**CITY OF LA VISTA**  
**MAYOR AND CITY COUNCIL REPORT**  
**AUGUST 18, 2015 AGENDA**

<b>Subject:</b>	<b>Type:</b>	<b>Submitted By:</b>
APPLICATION FOR PUD ORDINANCE AMENDMENT, ◆ RESOLUTION (2) FINAL PUD PLAN & CONDITIONAL USE PERMIT— COMFORT SUITES LOT 1, SOUTHPORT EAST REPLAT TWELVE (NE OF McDERMOTT PLZ. & EASTPORT PKWY.)	ORDINANCE (1) RECEIVE/FILE	ANN BIRCH COMMUNITY DEVELOPMENT DIRECTOR

**RECOMMENDATION REPORT**

CASE NUMBER: 2015-CUP-02  
2015-PUD-04

AS.1

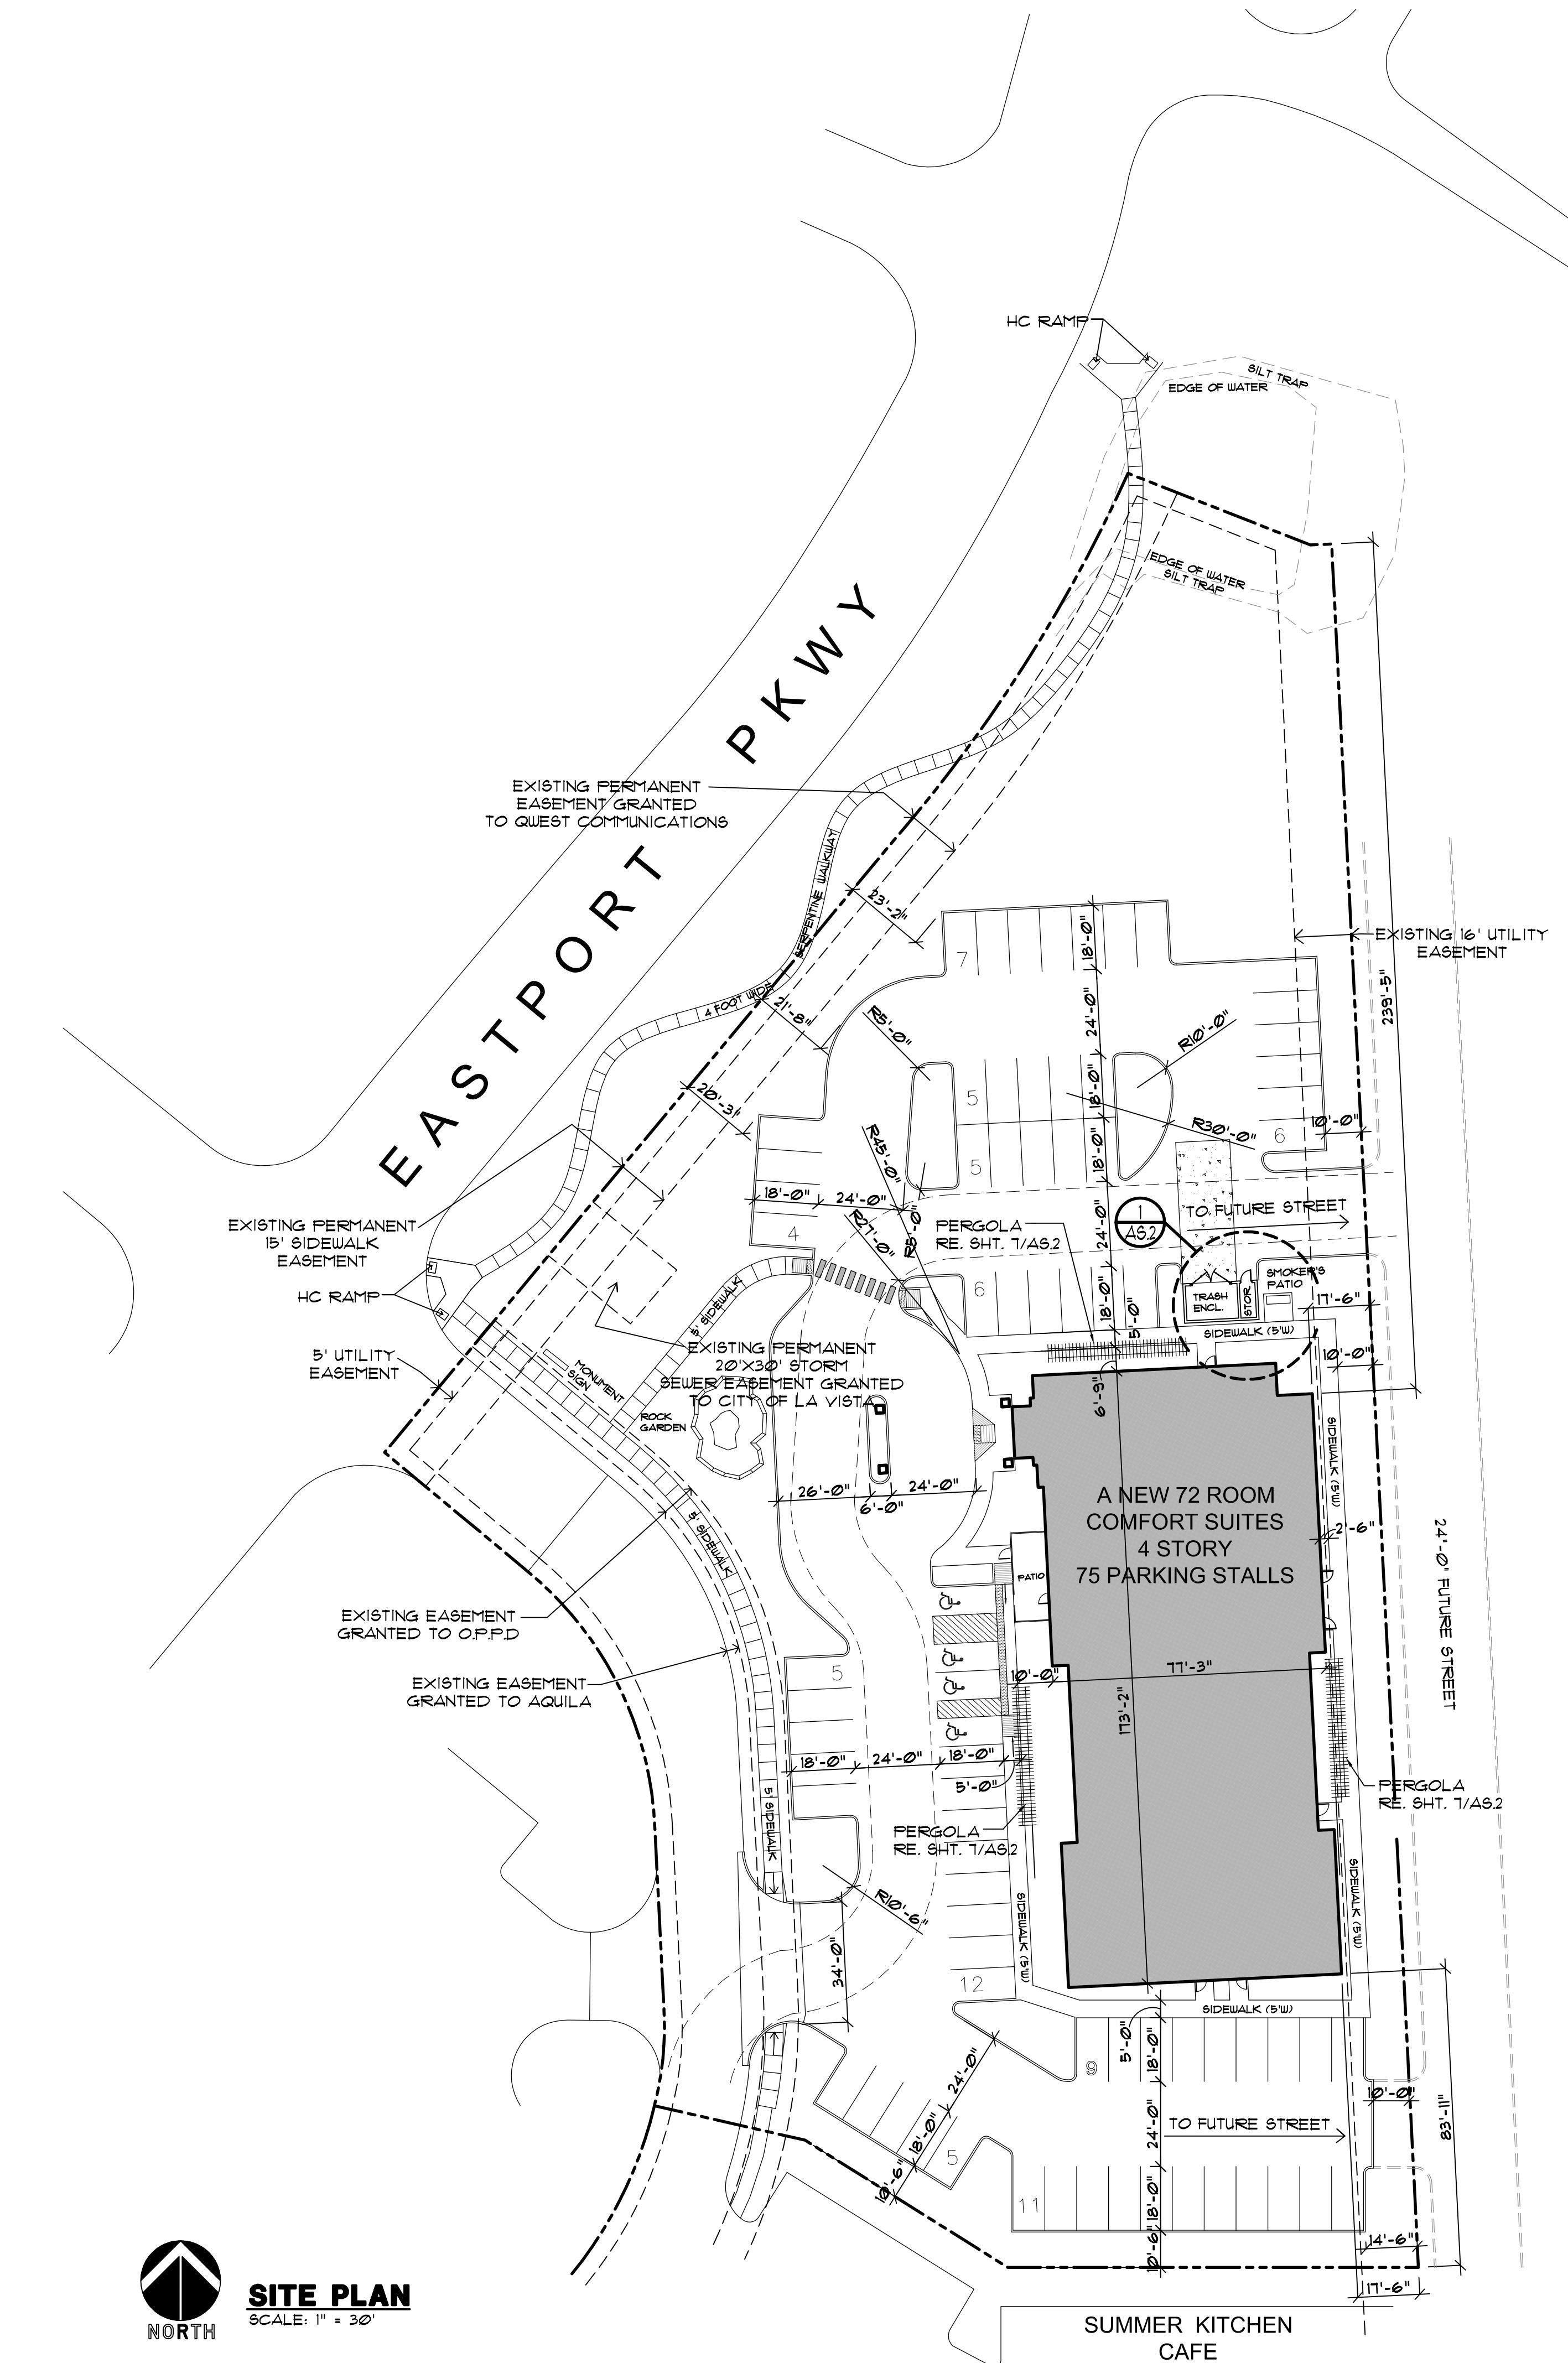
1. Detail 1 - Site furniture shown is limited to the smoking area bench. Is any other site furniture proposed? It seems like the pergola elements should have some bench seating available if they are contributing to the pedestrian experience of the walkways around the building.

3. Detail 4, where does the flag poles occur on the site?
4. Detail 8, note 5 – finish on pergola appears to have been changed to paint or maybe a semi-transparent wood stain. Submit a physical sample of Sherwin Williams "Bold Brick" applied on pressure treated wood for review and compliance with acceptable colors. (Refer to Appendix N. Minor Accent Color Ranges).

3. There will be no Flag poles in this project. Flag pole details deleted from sheet

2 TRASH ENCLOSURE ELEVATION

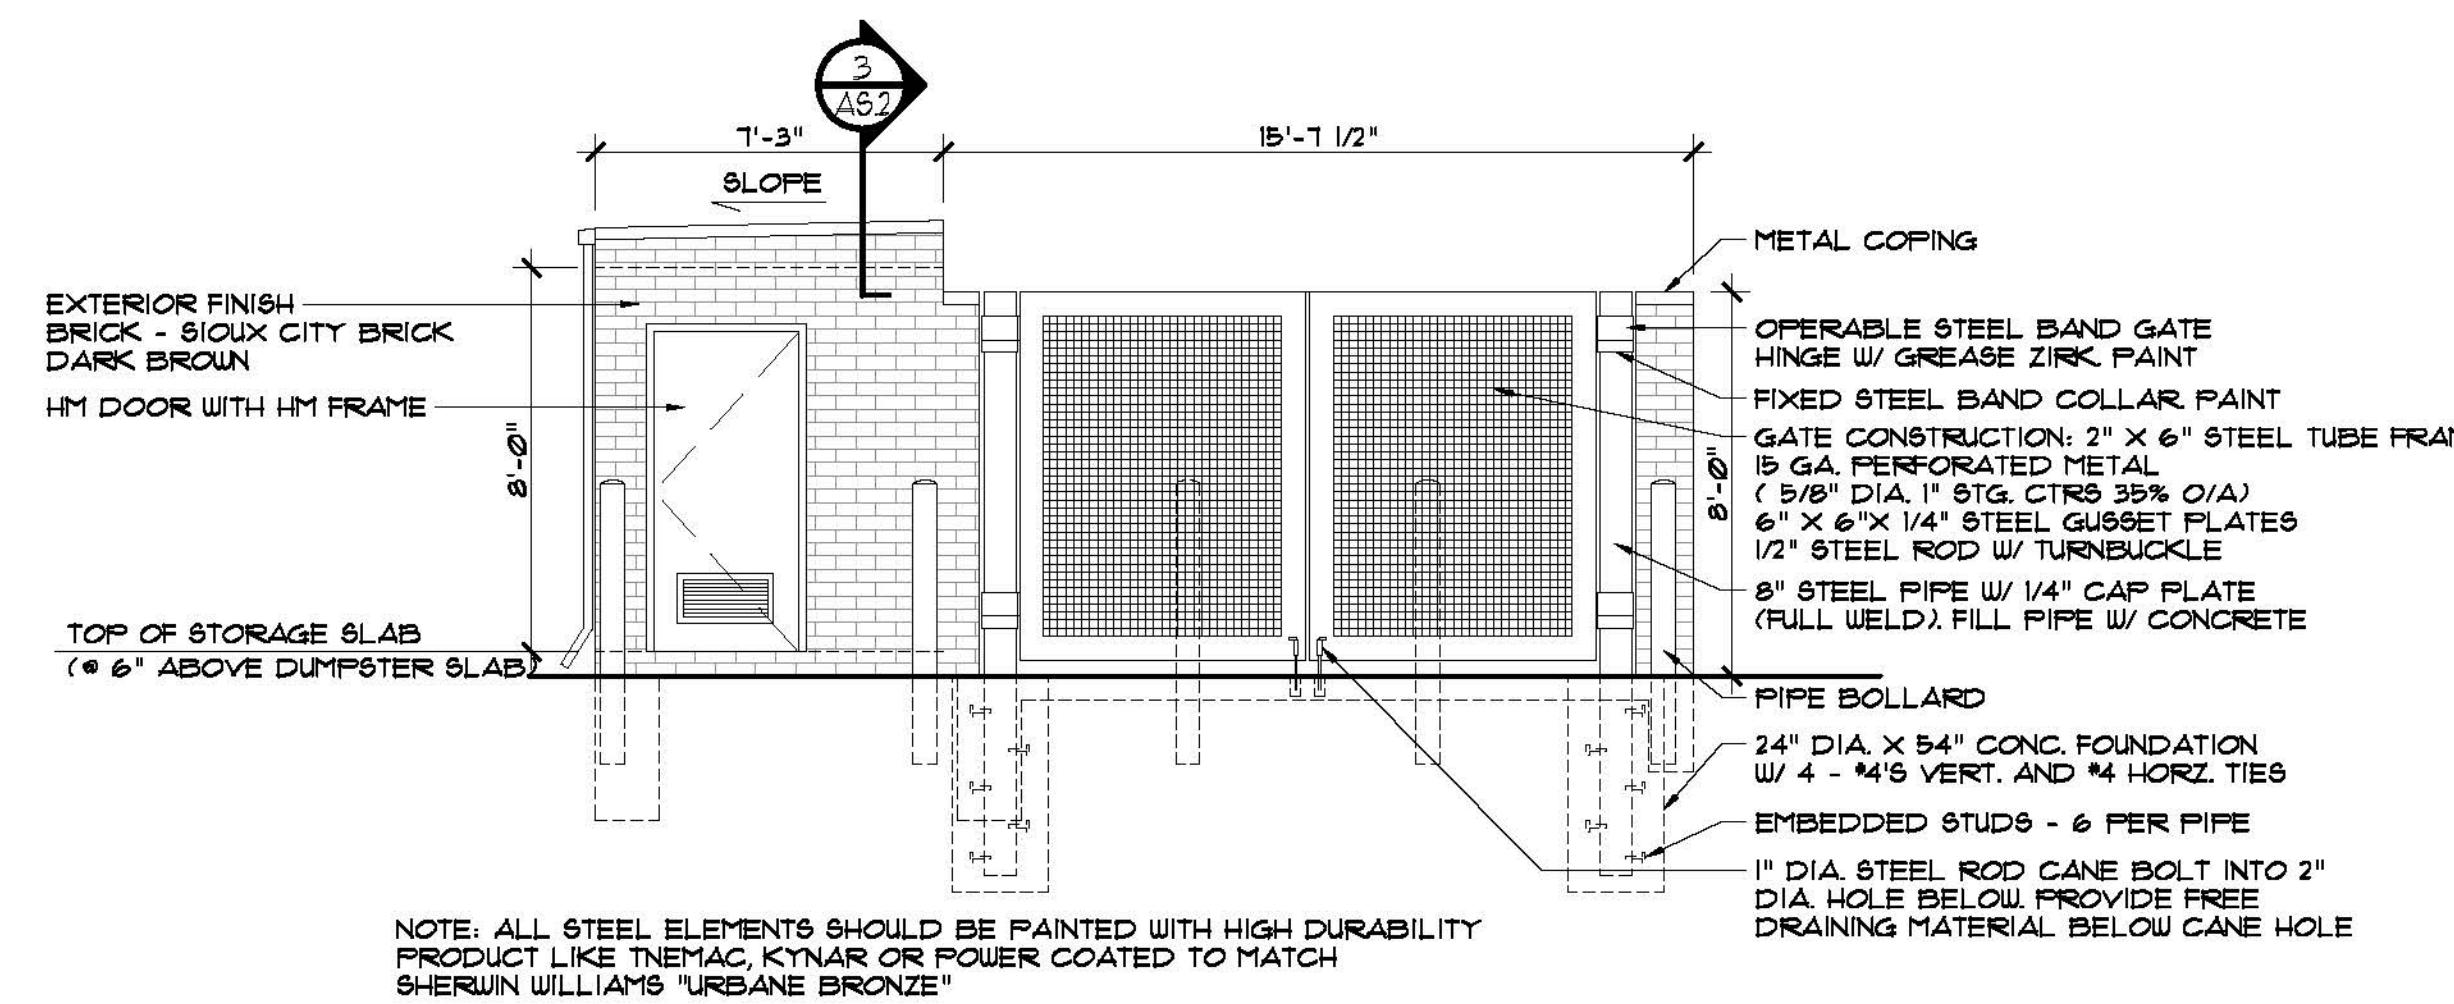
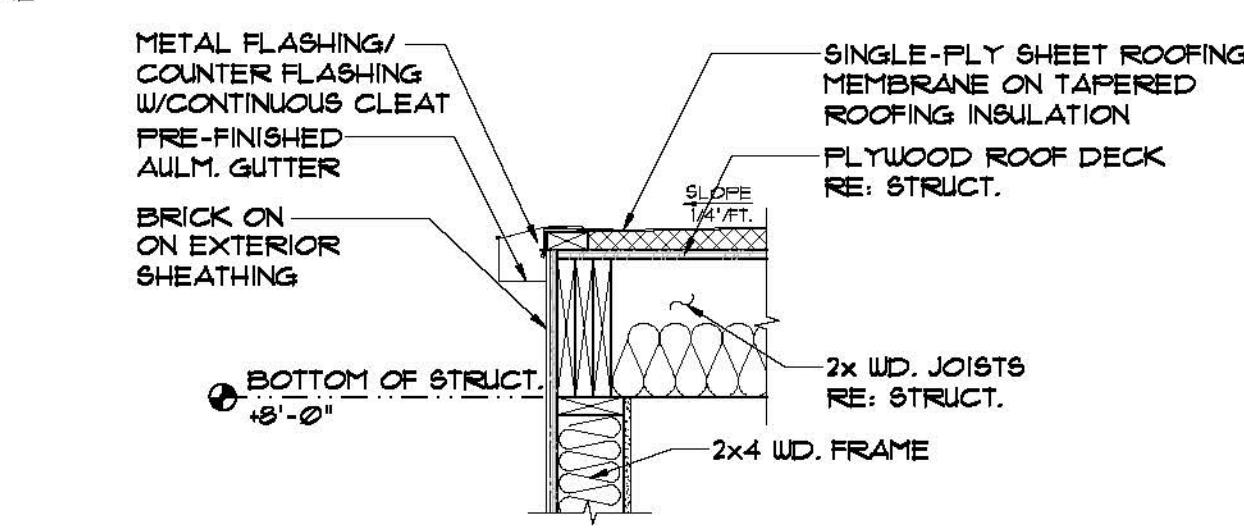
2. Detail 2 - the trash enclosure as submitted still does not meet the requirements. The trash enclosure walls and the attached storage room shown as painted wood fencing are required to be brick to match the building construction. The gate configuration is satisfactory. All steel elements should be painted with a high durability product like Tnemec, Kynar, or power coated to match Sherwin Williams "Urbane Bronze" to be consistent with the building accents. (Refer to Appendix R. Refuse Screen Gate).

2. Detail 2 on sheet AS.2 revised to show brick on trash enclosure walls and high durability product on all steel elements to match Sherwin Williams "Urbane Bronze".

5 PERGOLA PLAN

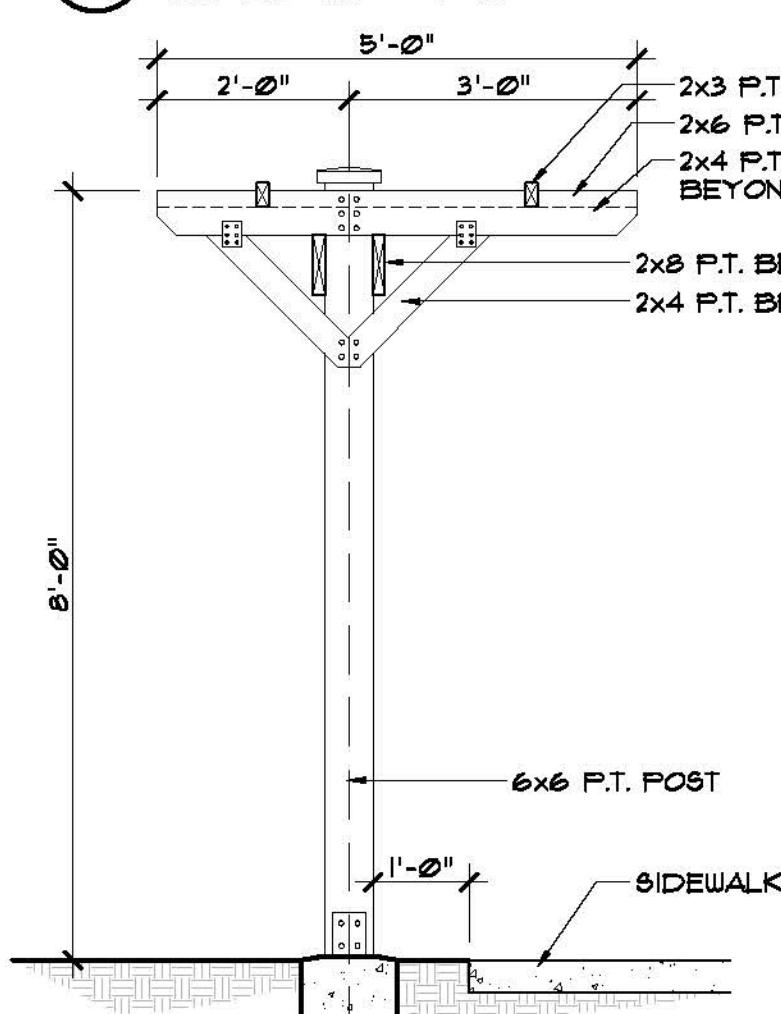
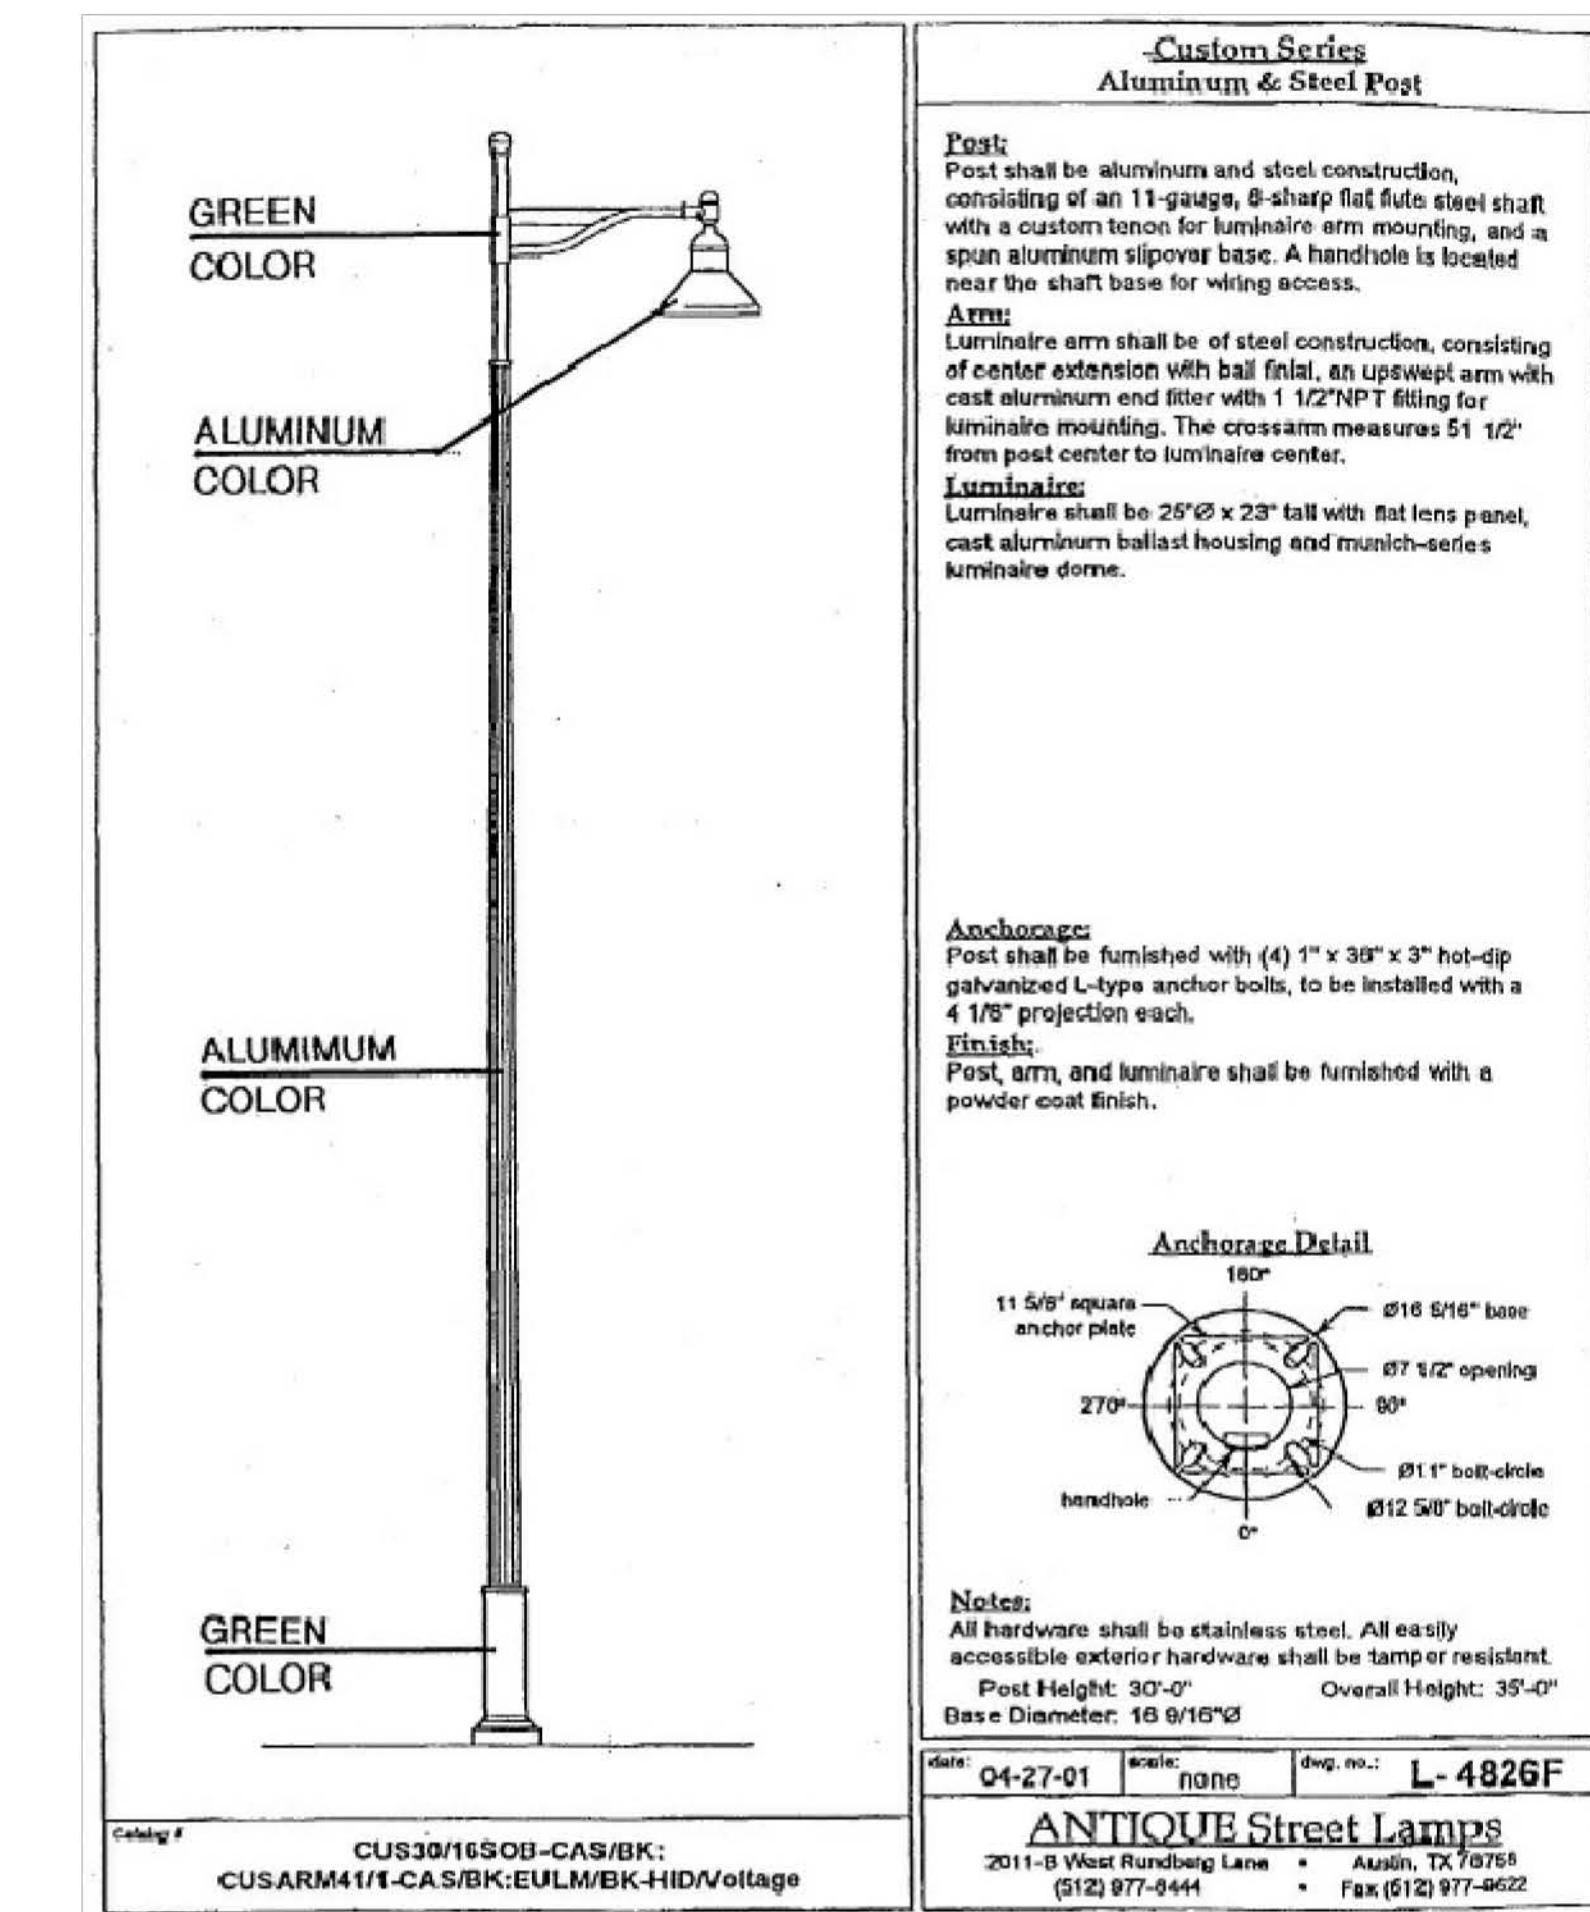
- b. Pergola element appears to have been set a standard 8' height per the detail on sheet AS.2. Recommend reviewing height to possibly be more integrated with the architectural lines behind it. The scale of the people and vehicles in the rendering seems off so this may be contributing to the pergola feeling understated.
